Access Compliance Report

Public Rights-of-Way

(Curb Ramps)

Intersection ID: N/A	Main Street: CRAIGHEAD_RD	Cross Street: N/A	Location: W
ADA ID: F18FEB90417B	Ramp Type: PerpDiag	Initial Pass/Fail: Fail	Overall Compliance: No
Severity Score: 13.75			
Codes/Mitigation Info/Possible Solution		Field Measurements/Component Compliance

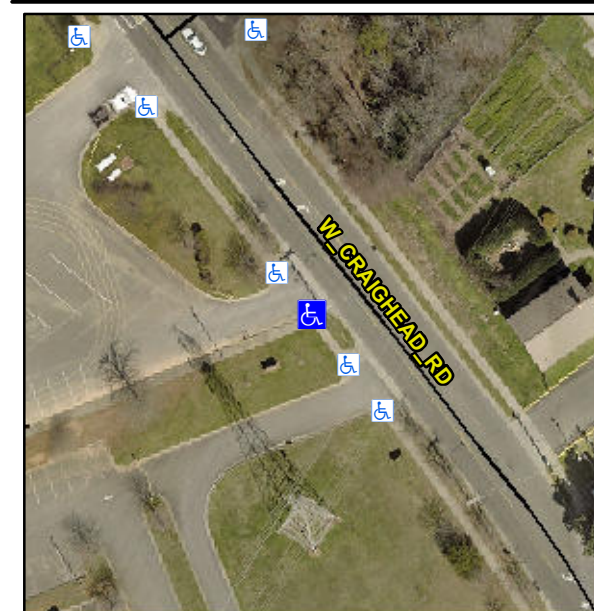
Not Found, R304.2.2, R304.5.3

Compliance	Description	Data	Compliance	Description	Data
N/A	Ramp Length (in)	60.0	No	Ramp Slope (%)	8.7
Yes	Ramp Width (in)	61.0	No	Ramp XSlope (%)	4.0
N/A	Flare Type LT	N/A	N/A	Flare Type RT	N/A
N/A	Flare Slope LT (%)	N/A	N/A	Flare Slope RT (%)	N/A
N/A	Flare Traversable LT?	N/A	N/A	Flare Traversable RT?	N/A
N/A	Landing Length (in)	N/A	N/A	DWS Provided?	N/A
N/A	Landing Width (in)	N/A	N/A	DWS Contrast?	N/A
N/A	Landing Slope (%)	N/A	N/A	DWS Length (in)	N/A
N/A	Landing X Slope (%)	N/A	N/A	DWS Full Width?	N/A
N/A	Landing Curb? (Y/N)	N/A	N/A	DWS Offset (in)	N/A
N/A	Shared Landing?	N/A			
N/A	Gutter Ponding?	N/A	N/A	Gutter Slope (%)	N/A
N/A	Gutter Lip Ht (in)	N/A	N/A	Gutter X Slope (%)	N/A
N/A	Painted X Walk1?	No	N/A	Painted X Walk2?	No
	X Walk 1 Direction	To E		X Walk 2 Direction	To NW
N/A	X Walk 1 Width (in)	N/A	N/A	X Walk 2 Width (in)	N/A
	X Walk 1 Slope (%)	1.3		X Walk 2 Slope (%)	2.4
	X Walk 1 X Slope (%)	4.3		X Walk 2 X Slope (%)	0.5

Remove & Replace Curb Ramp With Two New Directional Ramps or Equivalent.
